PANAMA CANAL AUTHORITY	VARIATION	PAGE 1 OF 5
1. REQUEST FOR PROPOSAL No.: RFP-76161	2. CONTRACT No.: CMC-221427	3. DATE: September 7, 2015
		4. VARIATION No.: 154

- (a) The Employer and the Contractor are party to Contract CMC-221427 for the Design and Construction of the Third Set of Locks, dated August 11, 2009 (as the same has been or may be varied, amended, supplemented or otherwise modified (the "**Contract**")).

- (b) The Contractor requested through RFV No. 255 dated July 30, 2014 a modification to Section 26 50 00 [Lighting Systems] of the Employer's Requirements to change the illumination zones in the approach areas such that there would be more illumination in the areas where the Employer's personnel would be likely to operate, and less illumination in other areas. The proposed change would have no time or cost implications to the Locks Contract.

5801-401

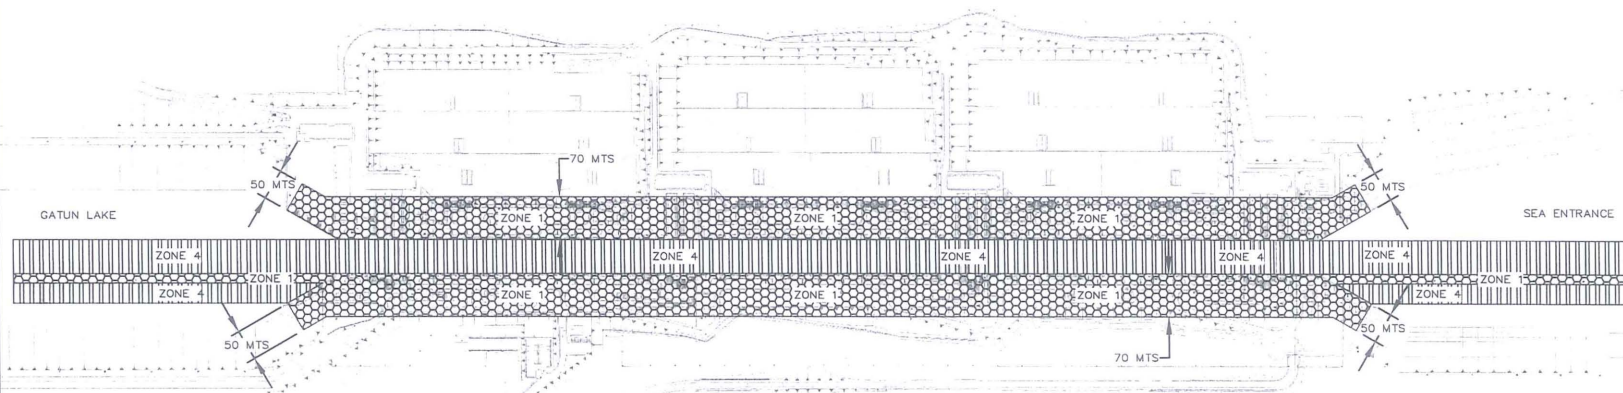
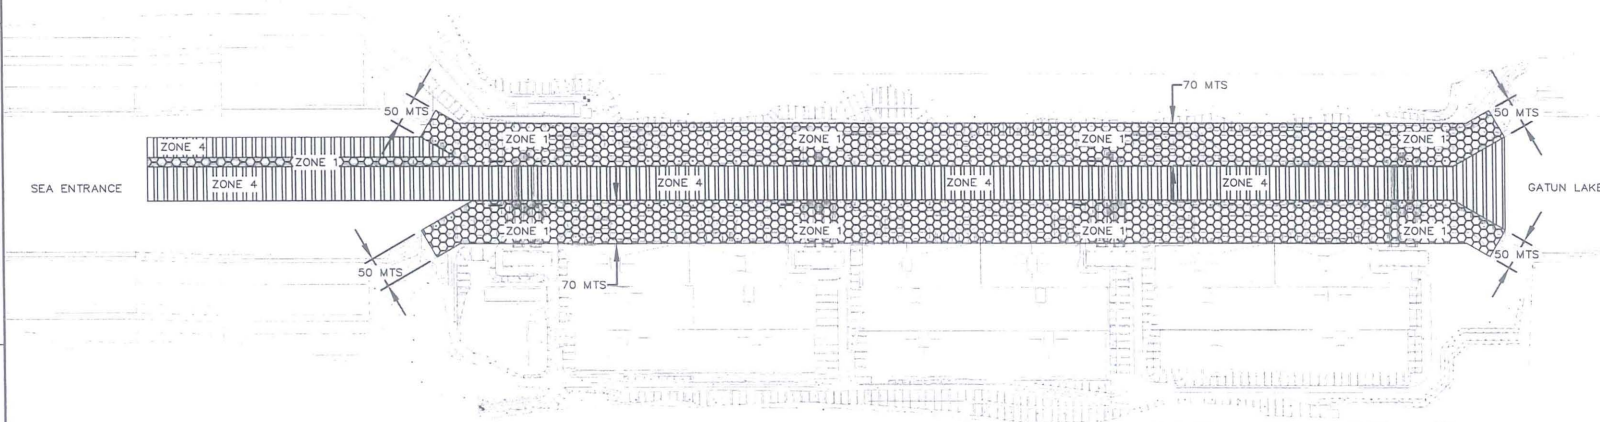
"b. Zone 1 shall consist of a 70 m wide area extending from the edge of each lock wall face towards the east and west shore sides, and extending the overall length of the three chambers. Also, Zone 1 shall also extend along the approach walls, with a width of 50 m for the full length of each approach wall. Refer to drawing No. 5801-400 for details."

"b. Zone 1 shall consist of a 70 m wide area extending from the edge of each lock wall face towards the east and west shore sides, and extending the overall length of the three chambers. Also, Zone 1 shall extend along each wing wall with a width of 50 m for its full length, and along the complete extension of the approach structure. Refer to drawing No. 5801-401 for details."

3. Replace Drawing 5801-400 with the revised Drawing 5801-400R1 and incorporate the new drawing 5801-401, both attached to this Variation Agreement No. 154.
4. Subject to the terms of this Variation Agreement No. 154, the Parties have agreed that the Employer is entitled to a reduction of USD 492,617.00 of the Contract Price as its 50/50 share of the total reduction resulting from the value engineering proposal (Price Details for Illumination Zones around the Approach Areas – VE Proposal) submitted with the Contractor's letter dated November 28, 2014 (GUPC-IAE-3285)
5. All of the Contractor's other existing and ongoing obligations pursuant to the Contract remain unaffected and nothing within this Variation Agreement No. 154

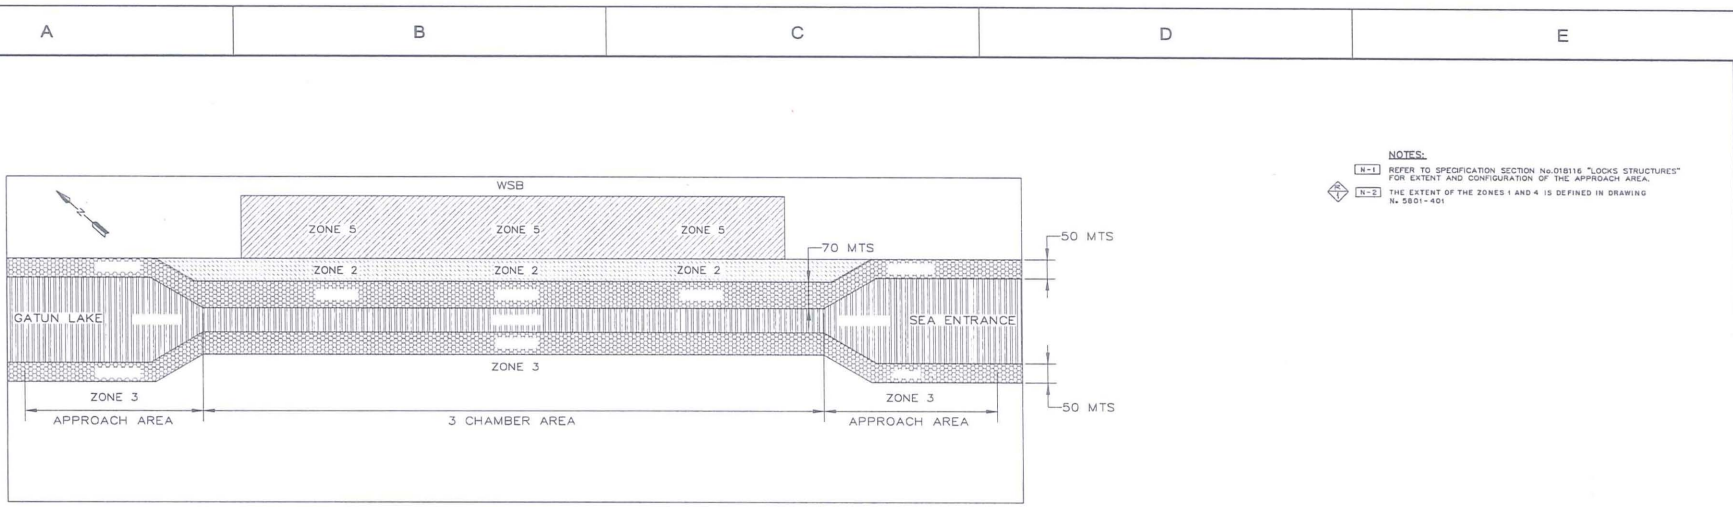
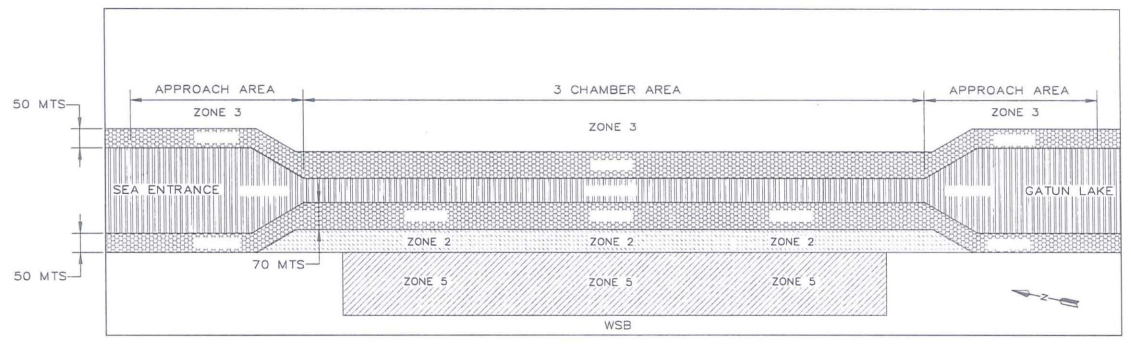
"C. Outdoor Area Illumination Level, Configuration and Equipment. The locks outdoor working area to be illuminated shall consist of five zones defined in Table No. 1, and drawing No. 5801-400 "Illumination Zones", (Refer to Vol. VI, Part 1, for location of drawings). Also to be illuminated is the perimeter fence area surrounding the locks, the approach and circulation roads within the locks complex."

"C. Outdoor Area Illumination Level, Configuration and Equipment. The locks outdoor working area to be illuminated shall consist of five zones defined in Table No. 1, and drawings No. 5801-400 R1 and 5801-401 "Illumination Zones". Also to be illuminated is the perimeter fence area surrounding the locks, the approach and circulation roads within the locks complex."
